PROPOSED REVISIONS TO FSAR SECTION 1.8,  
"QUALITY ASSURANCE PROGRAM"

WISCONSIN ELECTRIC POWER COMPANY  
ORGANIZATIONS WITH QUALITY ASSURANCE  
INTERFACE TO POINT BEACH NUCLEAR PLANT

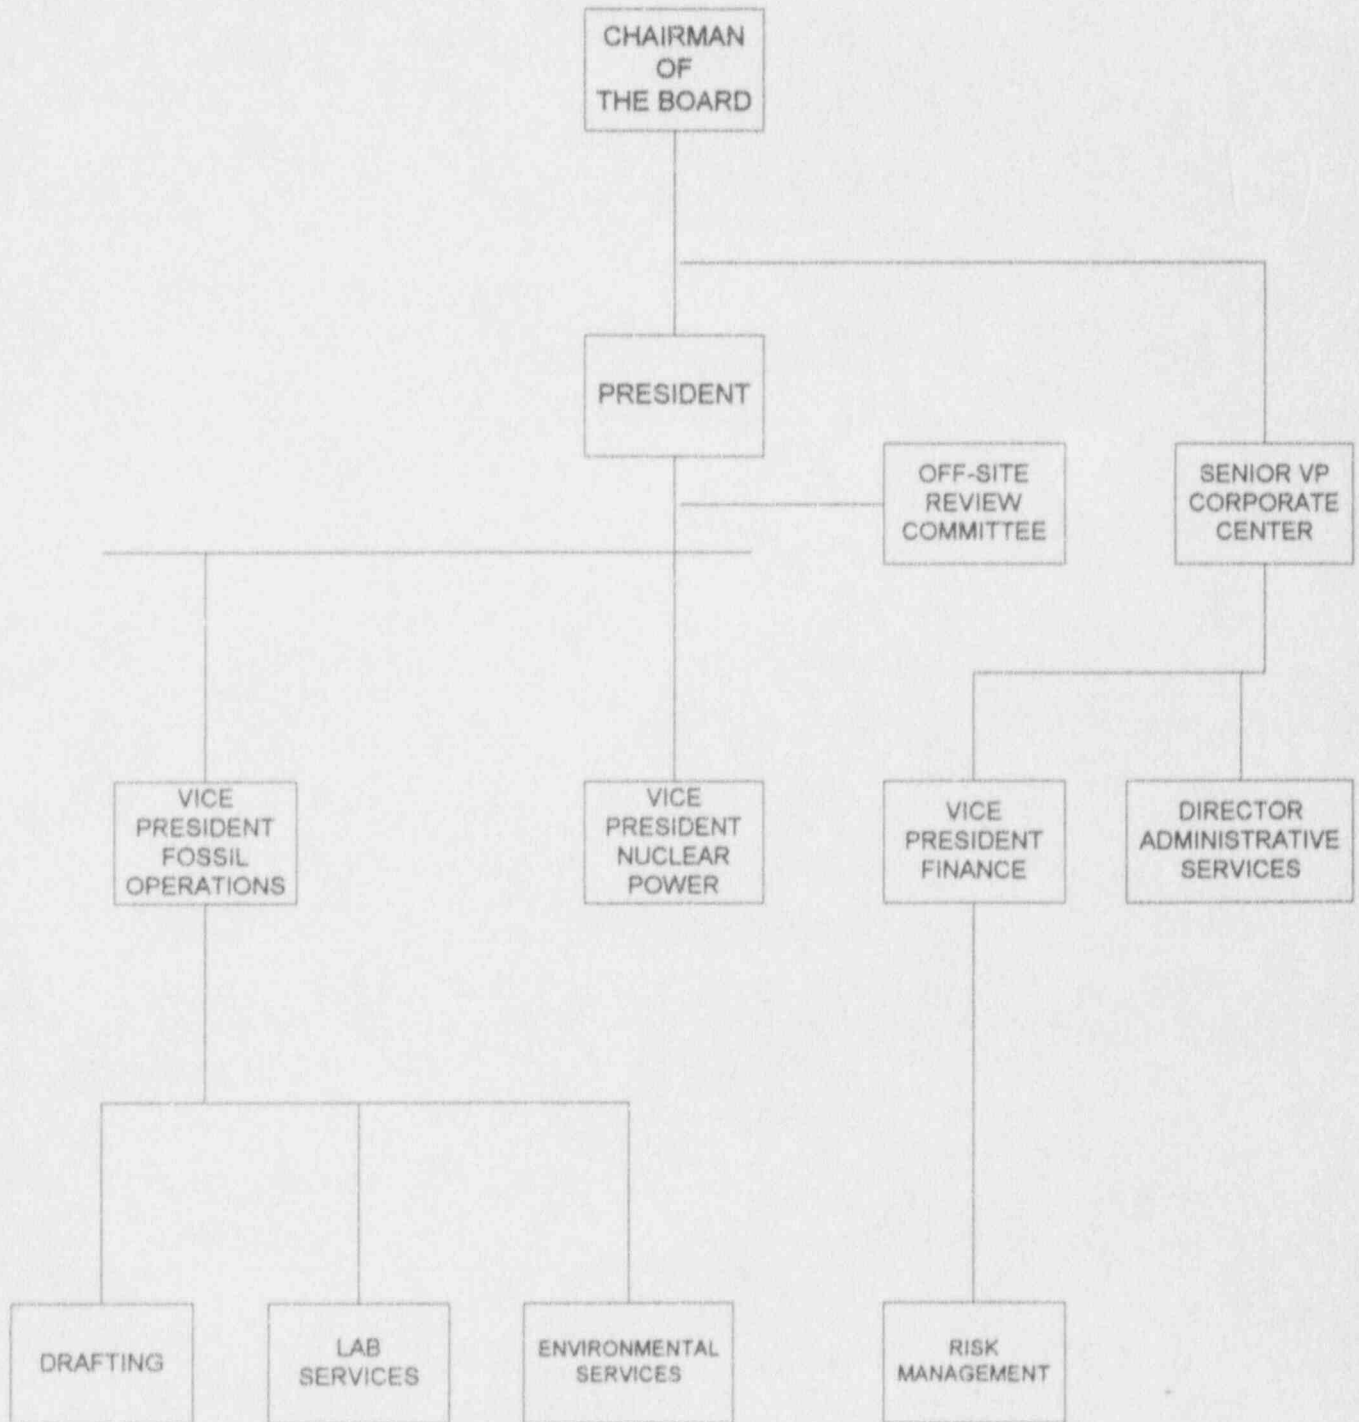
- Figure 1.8-1 This figure is being revised to reflect the appropriate organizational structure of Wisconsin Electric Power Company.
- Figure 1.8-3 This figure is being revised to reflect the appropriate organizational structure of the Quality Assurance Section.
